A14 Cambridge to Huntingdon Improvement Scheme

Bar Hill Junction

Stage 3 Road Safety Audit

Stage 3 Road Safety Audit 406395DS-TPN-ITD-117-A

Photo 7: Showing intersecting angle of SLTL with slip road

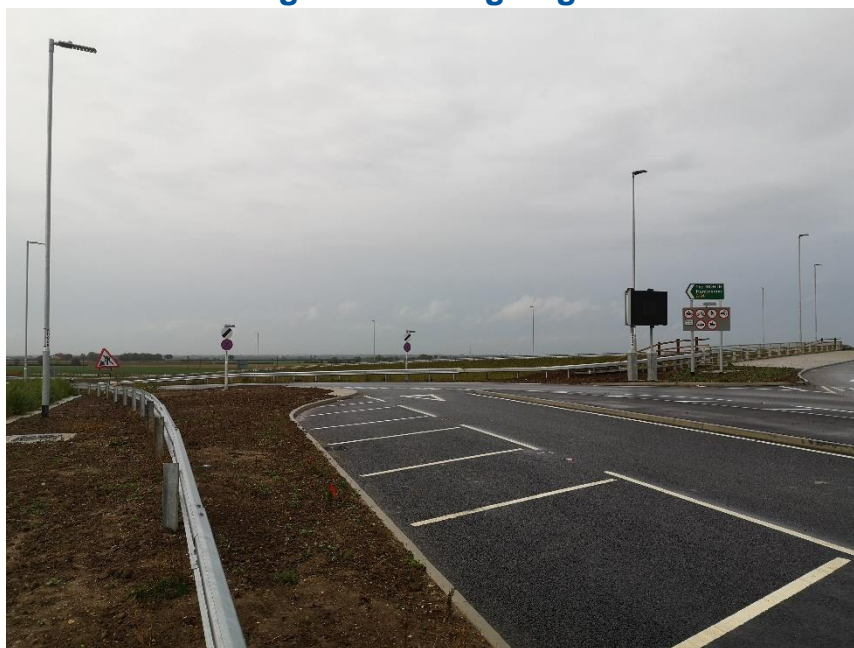
Location: SLTL to A14 westbound, at the give-way with entry slip road.

Summary: Alignment of the SLTL and intersecting angle of the give way point.

The alignment of the segregated left-turn lane / approach on to A14 westbound entry slip road is such that it creates a small entry angle (at approximately 30°).

This requires the driver to come to a stop and look over their shoulder or use their mirrors to gauge a suitable gap to allow them to join the circulating traffic. It was observed that some drivers were experiencing difficulty when undertaking this manoeuvre.

There is a risk that this continued behaviour may increase the risk of rear end shunt type collisions at the give way line or has the potential for drivers to misjudge vehicles exiting the roundabout, resulting in conflicts.

It is recommended that measures to create a larger entry / intersecting angle with the slip road are investigated.

B-1 Key Plan, Section 4 Bar Hill Interchange – Sheet 1 of 1

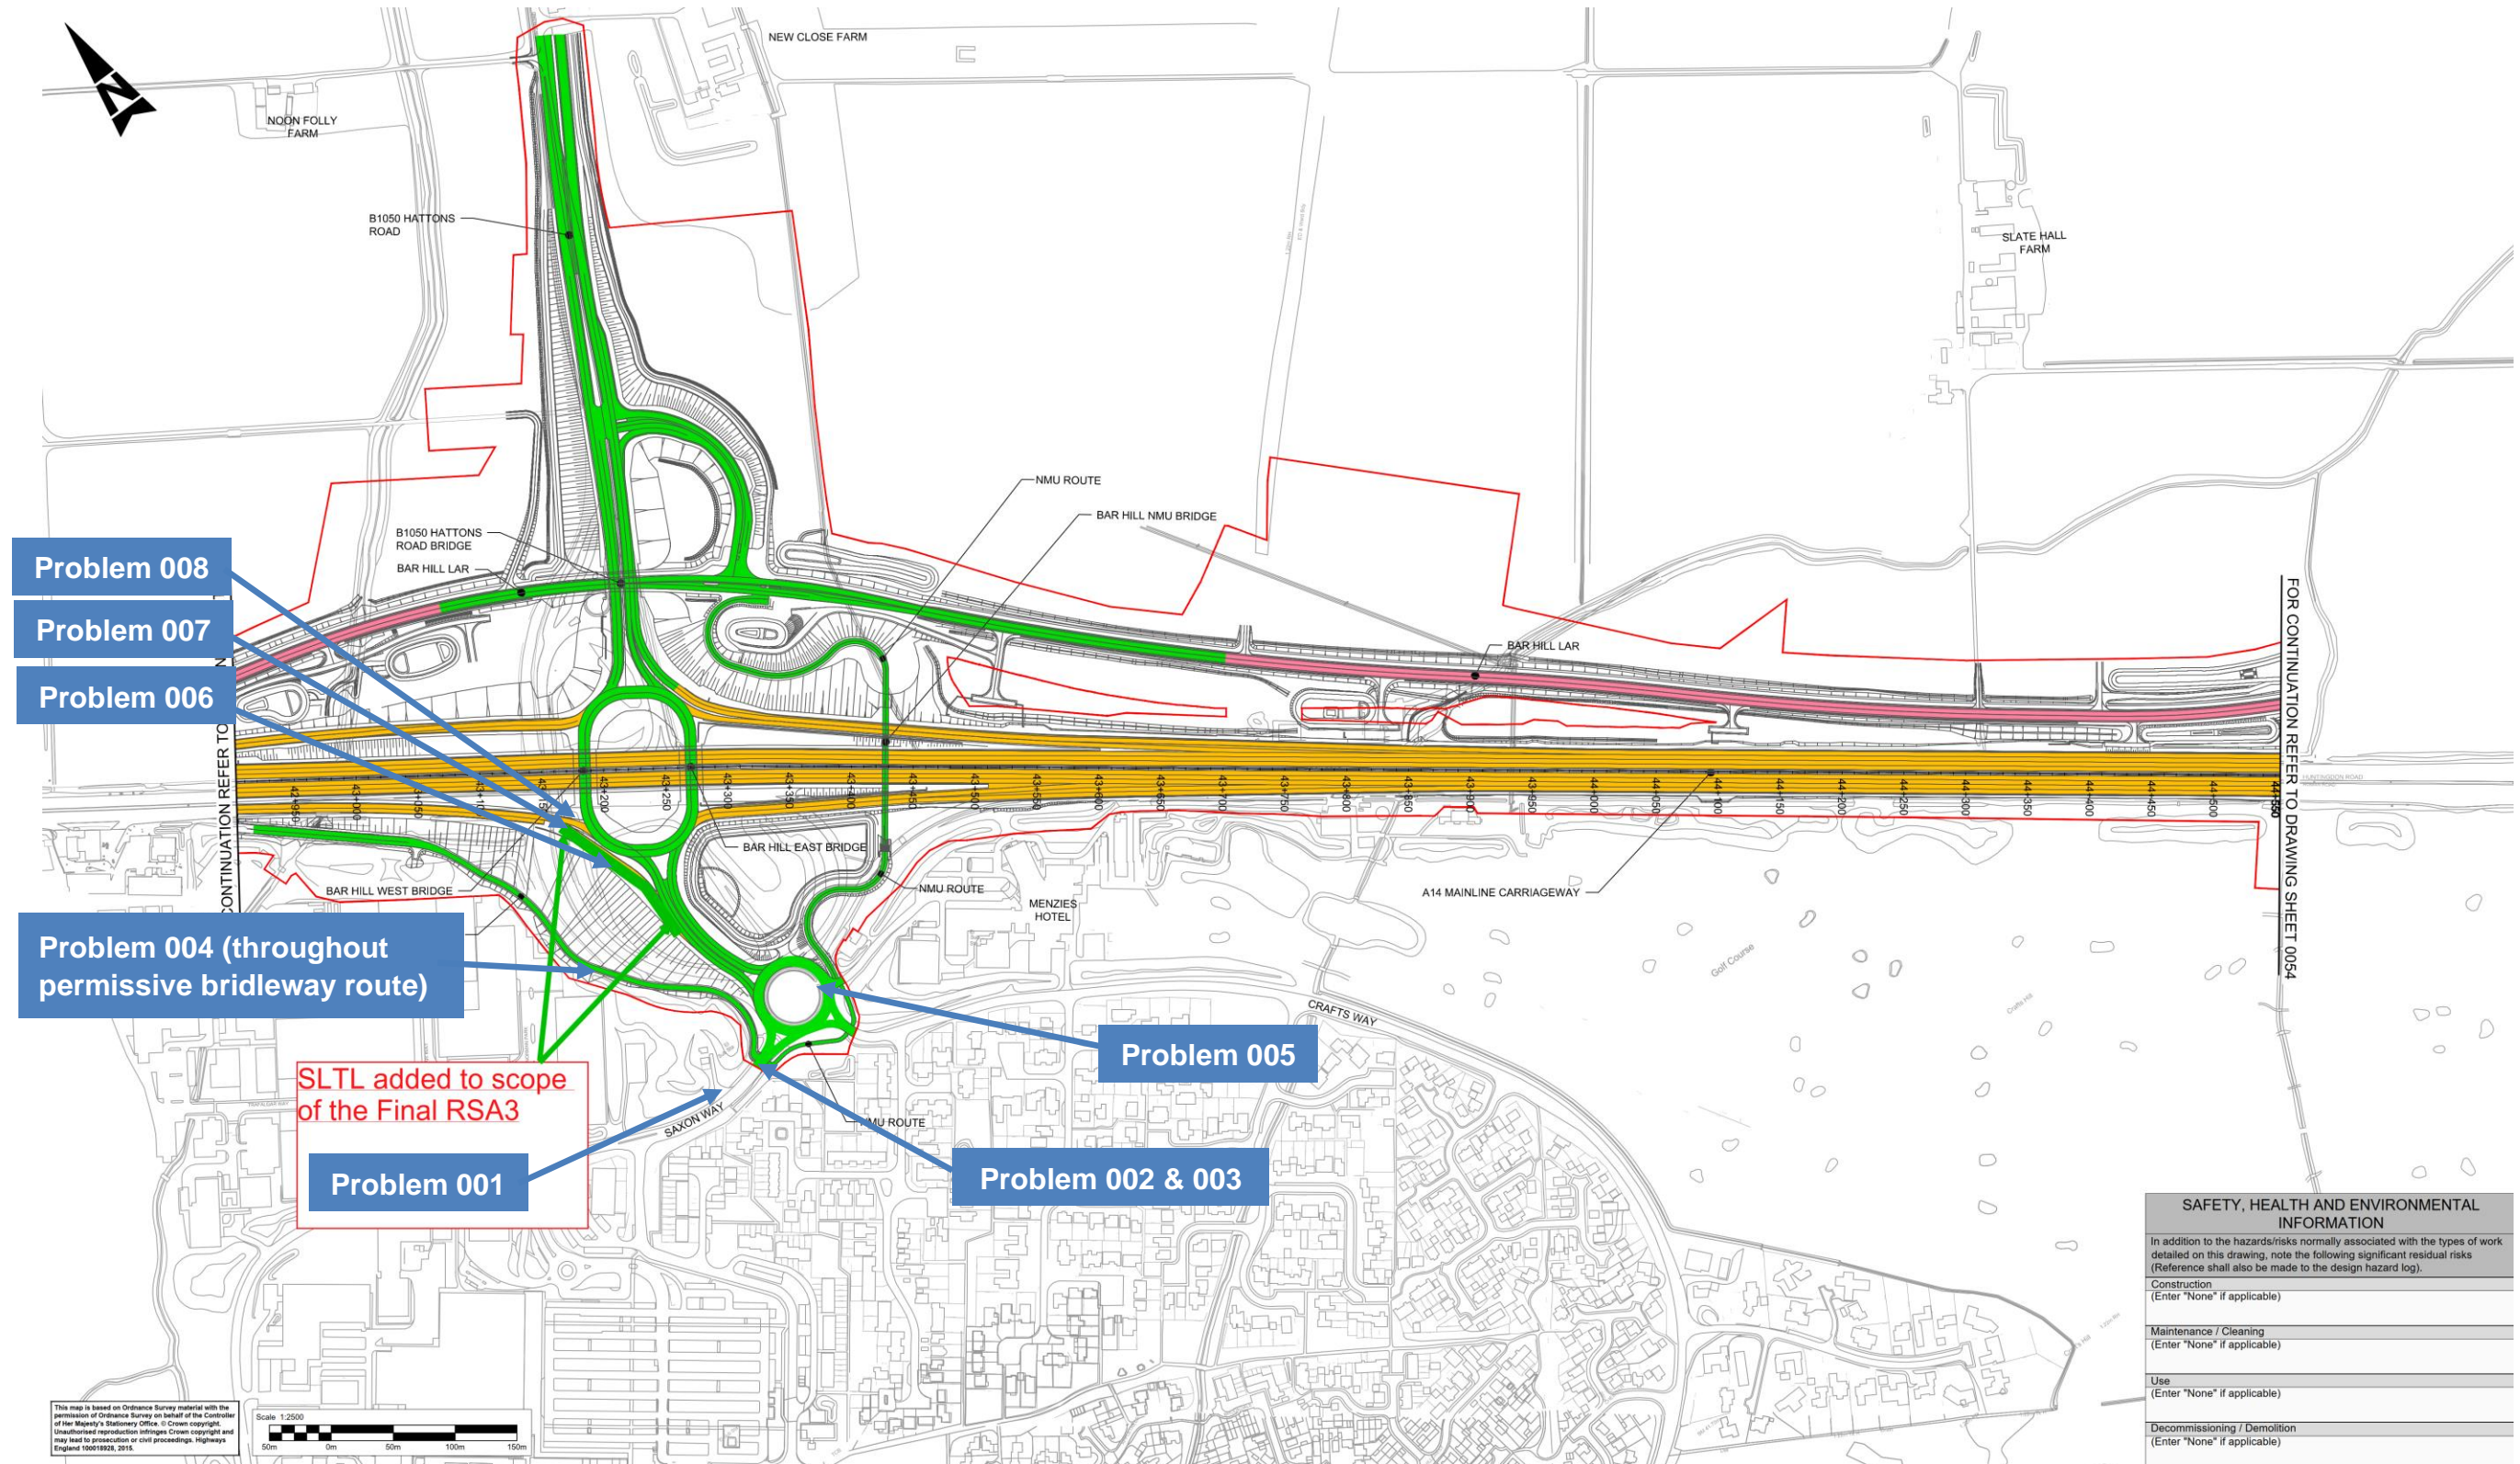
Problem 008

Problem 007

Problem 006

Problem 004 (throughout permissive brideway route)

Problem 001

Problem 005

Problem 002 & 003
